**MAS Comments to the Board of Standards and Appeals, Application No. 2016-4327-A.
Appeal by Sky House Condominium regarding permit issued for 15 East 30th Street, NY, NY**

September 20, 2017

Figure 1: Perspective of proposed development at 15 East 30th Street highlighting structural voids

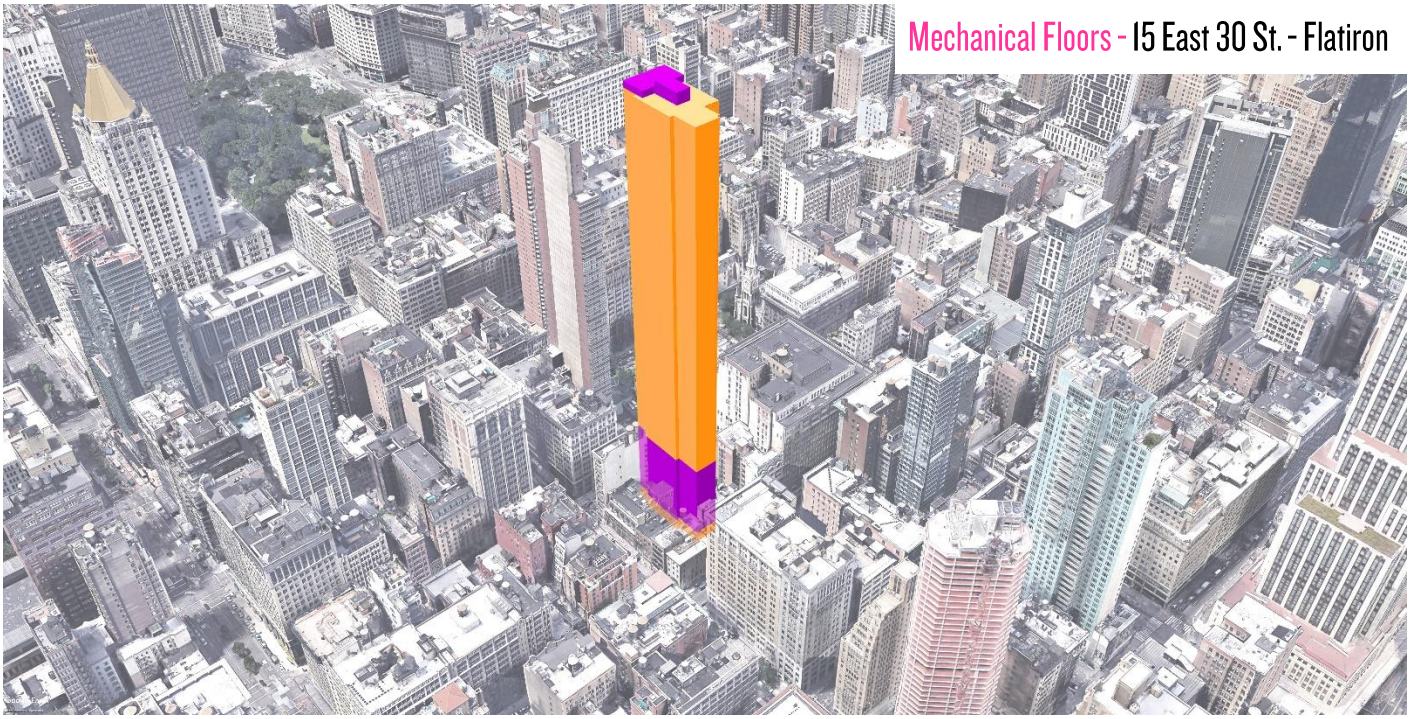
As part of the building permit in question, the developers requested to construct five mechanical floors comprising over 150 feet in height, which would result in an approximate 23% of the total tower's volume dedicated for accessory mechanicals (see figure 1 and 2). The ZR is clear in that enclosed spaces should count as floor area, with the exception of certain uses, including mechanical space. However, the applicants describe these areas as a "structural void", which incidentally hold limited amounts of mechanical equipment that is not proportional to the size of the space. MAS questions what type of mechanical, electrical, and plumbing equipment demand such a staggering amount of volume?

The practice of using "structural voids" into the design of a building in order to boost height is a relatively new phenomenon in New York City. Many new towers disguise these voids as accessory building mechanicals, and incorporate them solely to increase heights, views and prices. Several developments currently under construction have exploited this misrepresentation of the ZR, perhaps most notably is 217 57th Street (also known as Nordstrom tower) where 350 feet of its height is devoted to structural void.

DOB's interpretation of the exemptions for contributing Floor Area under section 12-10 of the ZR is resulting in structural voids being used without any regulatory limit. Such practice is severely undermining the 12 FAR limit on residential buildings mandated by state law. Without proper examination that all such space is necessary for the building mechanicals, DOB is indeed misrepresenting the ZR and making policy on behalf of lawmakers. The BSA must strictly evaluate the primary use of these spaces and whenever necessary overrule these inappropriate building permits.

We recommend BSA take the lead in examining this issue and coordinate with the City Planning Commission (CPC) to determine appropriate heights for mechanical floors in building permit applications.
